Does TDECQ Capture Jitter

Addressing D1.1 comments: 67, 78, 82, 95, 182, 561, 564, 565, 571, and 577

IEEE 802.3dj Interim Meeting

September 16, 2024

Jitter Characterization of Test Cases

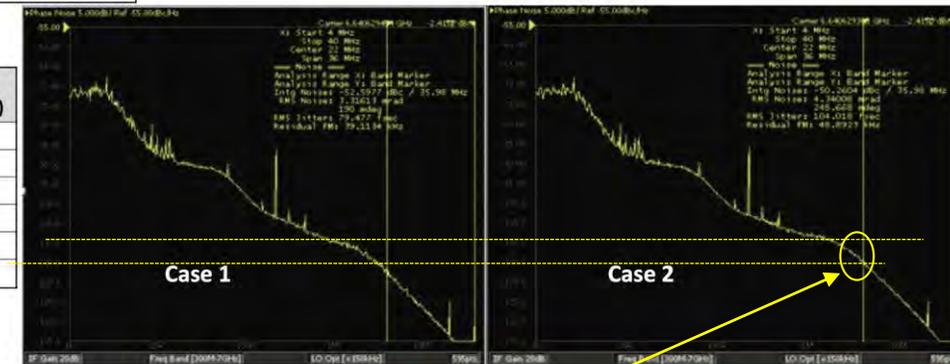
Tiny amount of phase noise increase results in error floor

Figure 121-5—Illustration of the TDECQ measurement

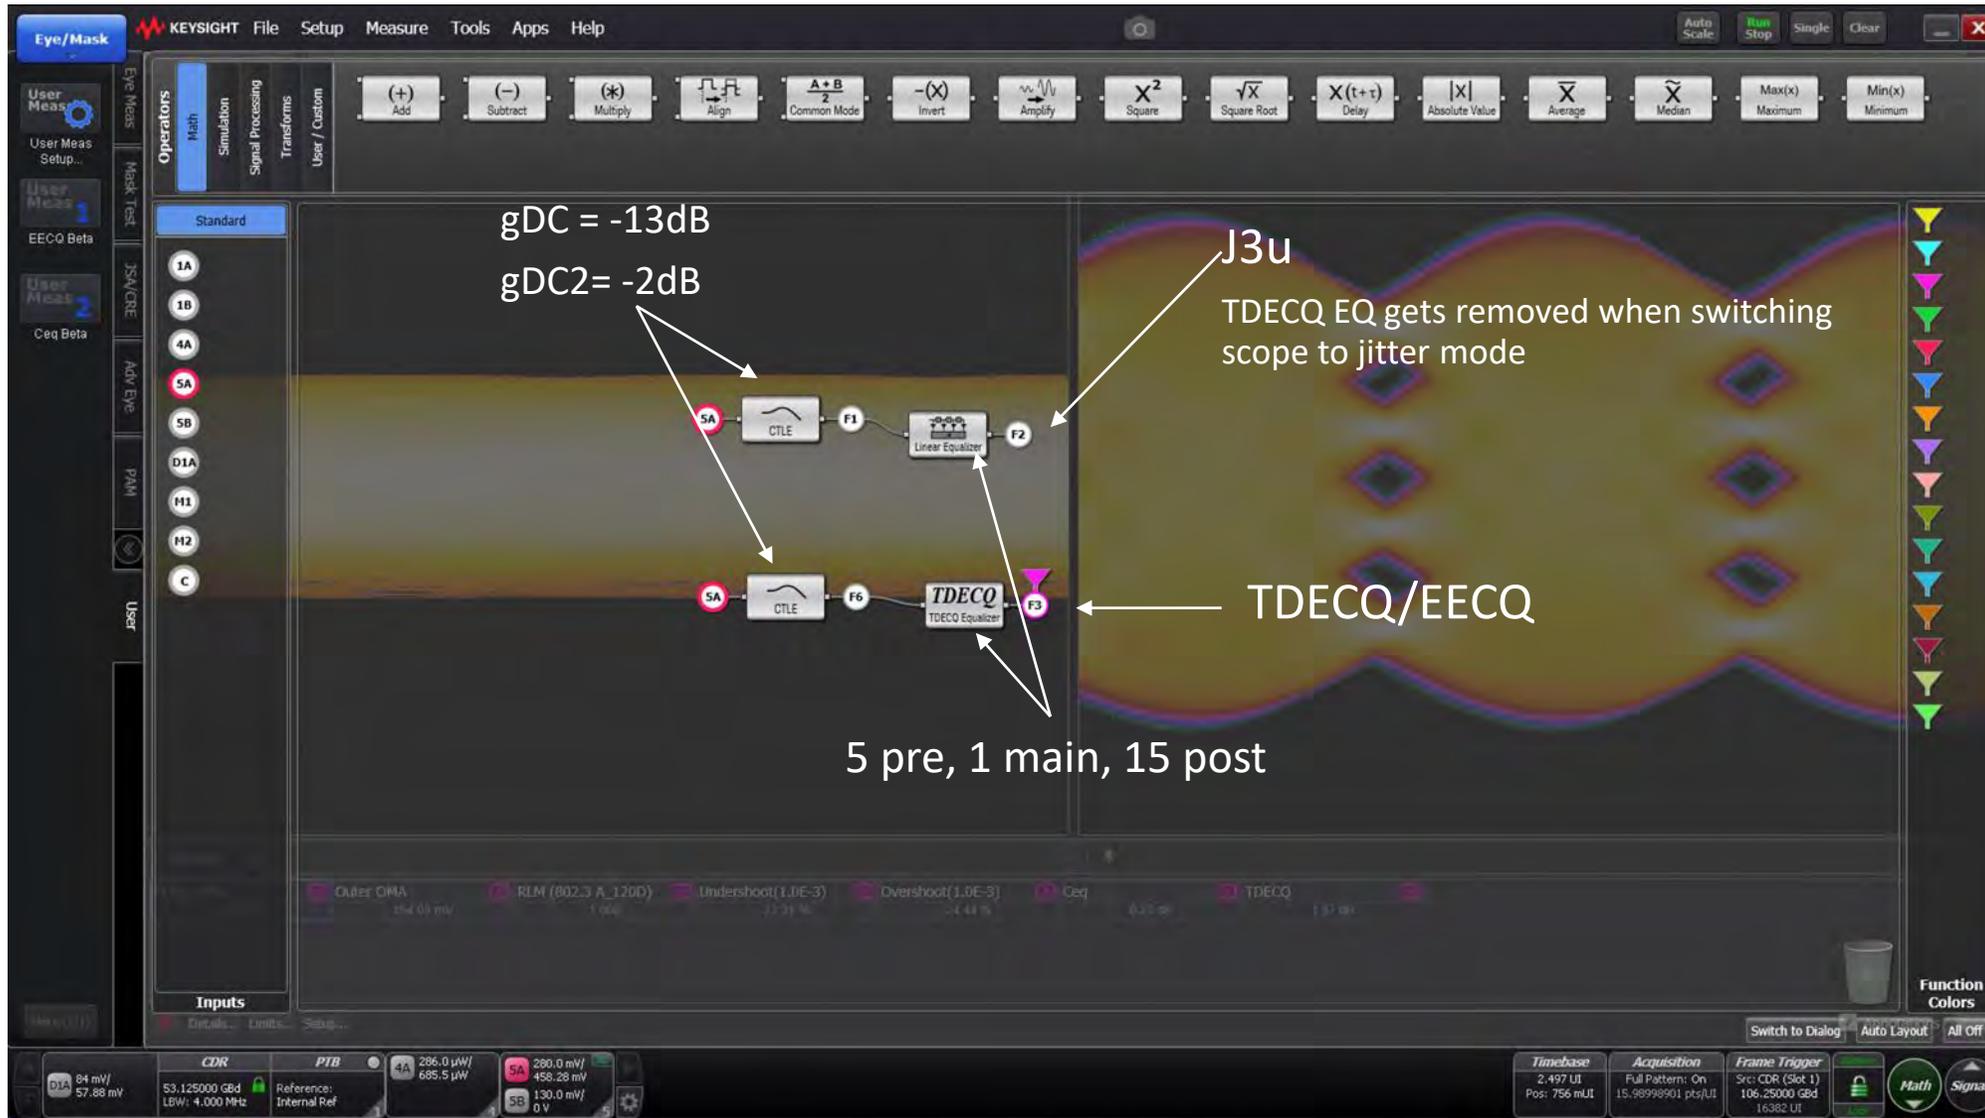
□ The short answer is – Yes

- All the wander and jitters due to pattern dependency, jitter multiplication, jitter peaking if data propagates from TP1 to TP2 and will get filtered by the Golden CDR and will get displayed on the scope
 - Each histogram window is 0.04 UI and the two histogram are separated by 0.1 UI
- The two histograms are measured at $4.8E-4$ but histogram confidence not defined
 - Assuming confidence level of 99% one would need to capture ~ 100 kSa (each histogram window assuming you get hit for each require only need 100 kUI)
- In today's sampling Oscopse with SSPRQ pattern typical acquisition time is ~ 3 seconds
 - J4U for sufficient confidence require 100k PRBS13Q waveform capture at sampling rate of 250 kSa/s for Oscopse will take ~ 1 hours!

EECQ/TDECQ Correlation to Input Jitter

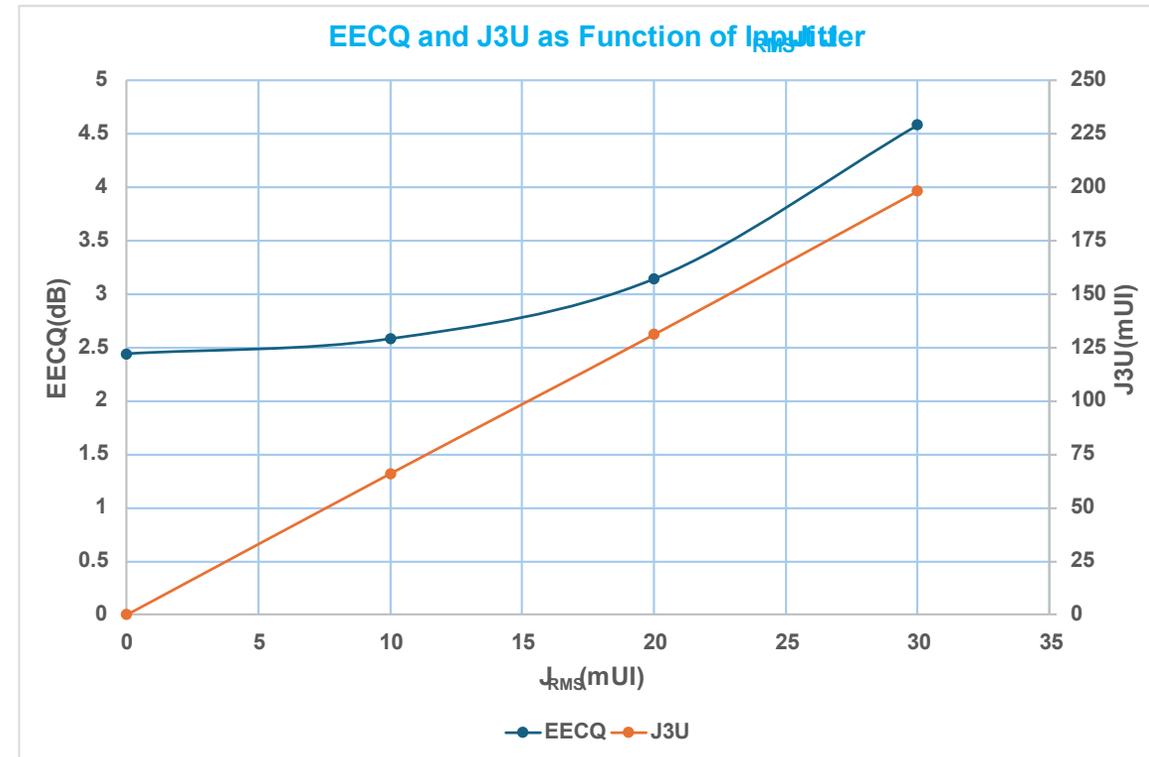
- ❑ Simulation show that there is strong correlation between EECQ/TDECQ and J3U as function of input J_{RMS}
 - J3U is a redundant measurement that is less effective than EECQ/TDECQ measured with a more representative SSPRQ pattern
- ❑ EECQ/TDECQ are very effective to capture jitter
 - The key is to make sure stress input applied to module input propagates to TP2 for TDECQ test otherwise jitter or impact jitter peaking will not be captured by TDECQ test or any other test!

JTOL Spot Frequency Check

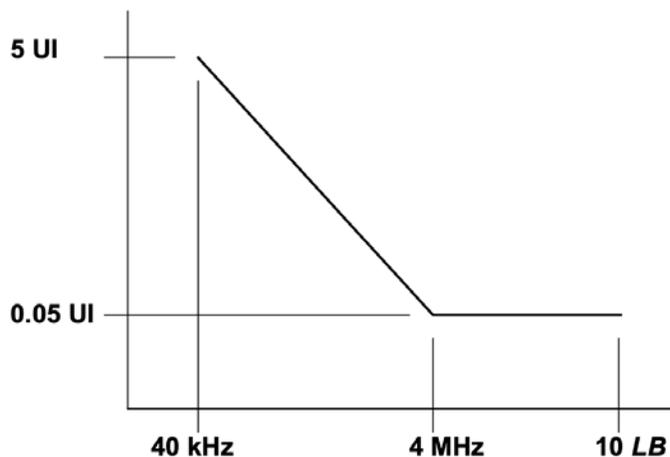
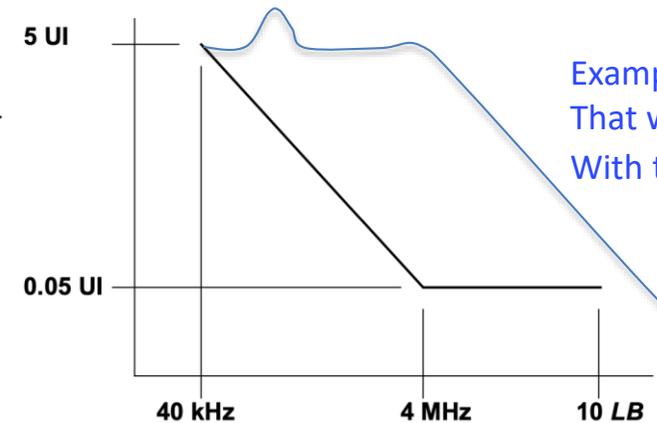
□ Spot frequency check can create holes in specifications especially when we have no limit for jitter peaking

- CDR designer may design around the JTOL frequencies and introduce large jitter peaks in untested bands
- JTOL need to be tested at least at every octave
- 6 test frequencies are just inadequate!

Example of Bad CDR Design That won't be caught With the 6 test frequencies.

What May be the Real Problem

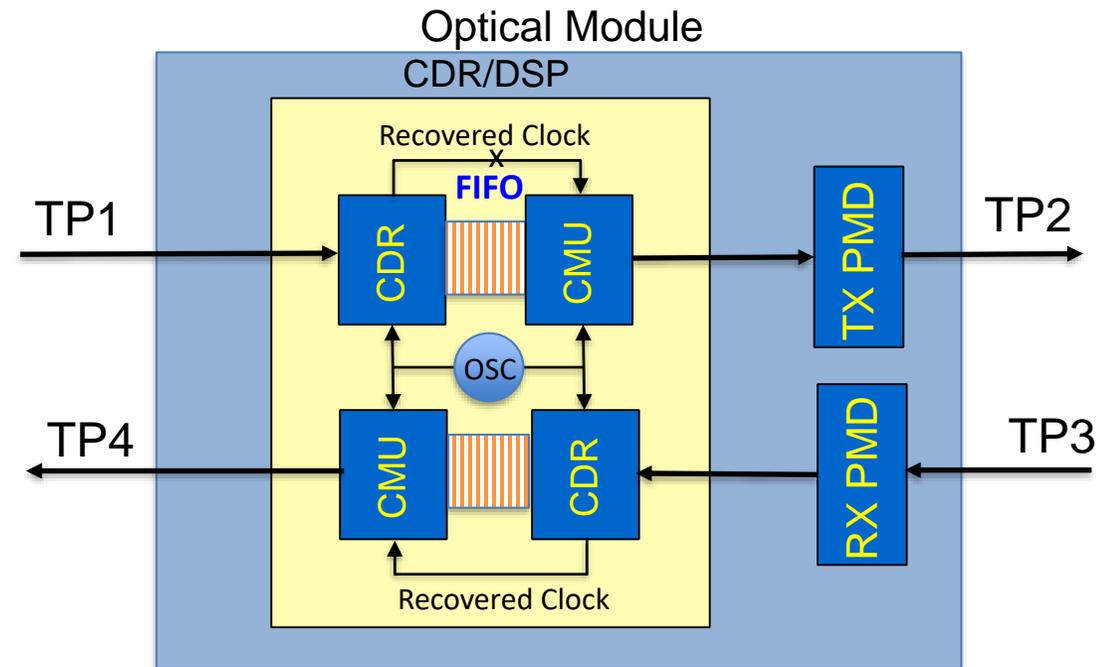
- ❑ **Current specifications are unclear how optical transmitters are tested for TDECQ when there is an optional AUI C2M present**
 - AUI C2M stress tested separately
 - SSPRQ is generated in the CMU mode without jitter and stress from AUI passing through the CDR
 - Applying stress input with SSPRQ at TP1a maybe too stressful for the CDR due to SSPRQ fast disparity changes
 - Instead PRBS31 would need to be applied at TP1a then the recovered clock must drive CMU generated SSPRQ pattern
 - Testing TDECQ with CMU generated pattern without any propagated jitter may have detrimental consequences for the system and likely the top reason for some of jitter anomaly reported [ran 3dj 02a 2407](#).

CMU Generated Patterns Misses Jitter Multiplication due to 2:1 Mux

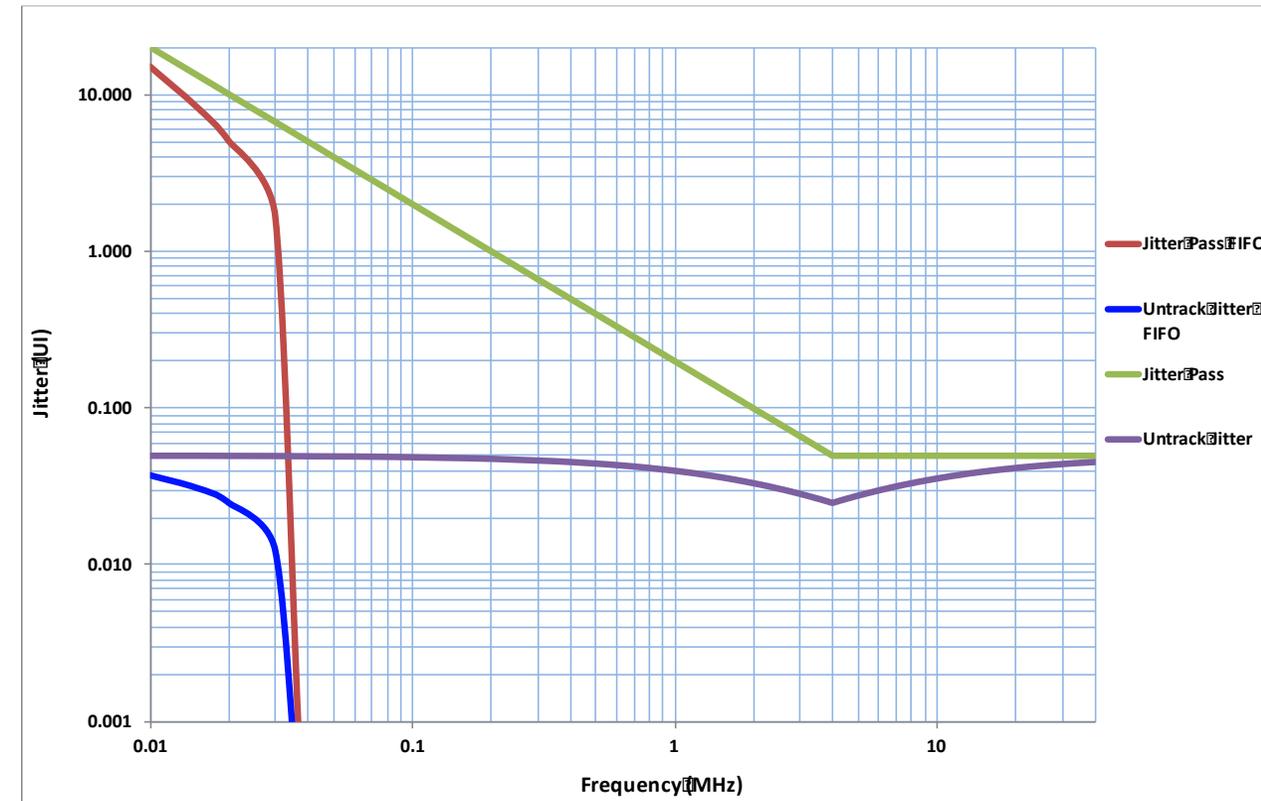
□ Given that we didn't double the CDR BW with doubling Baudrate the CDR/DSP requires tricky FIFO to avoid excess jitter generated from 2:1 Mux

- Another tricky part of this FIFO is that the implementation must track without running out of FIFO and without using a very large FIFO but with right implementation practically there is no penalty, see [ghiasi 3dj 01a 2305](#)
 - A 2:1 mux chip with 5 UI (input serial bitrate) FIFO practically speaking has no penalty
 - A 2:1 Mux with no FIFO would have 0.05 UI of penalty
- For any type of transmitter/TDECQ unless the data is sourced through CDR/FIFO we maybe missing significant penalty!

Backup Up Approach to Capture TP2 Jitter

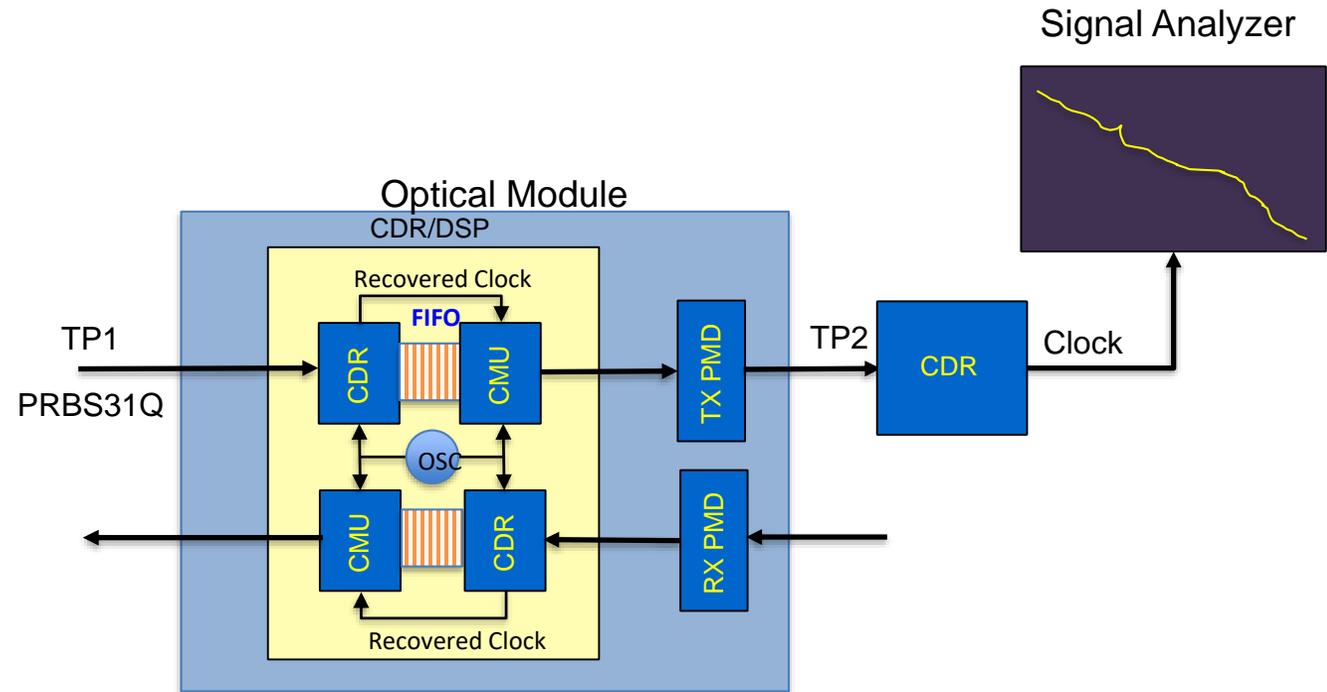
- In ideal world TP1 can be driven by stressed SSPRQ then the recovered data propagates to TP2 but SSPRQ containing transition density of PRBS31 that repeats in 2^{16} bits may break the CDR
 - Applying PRBS31Q to TP1 is a viable method then the recovered clock driver the CMU and SSPRQ
 - But this method will not exercise the mission mode FIFO, alternate method would need to be used to test the FIFO

- The backup approach to capture jitter and leverage SONET jitter generation method
 - With PRBS31Q or Ethernet traffic recover the clock with Golden CDR then integrate the phase noise
 - Jitter Gen ≤ 10 mUI measured from 40 kHz to 80 MHz.
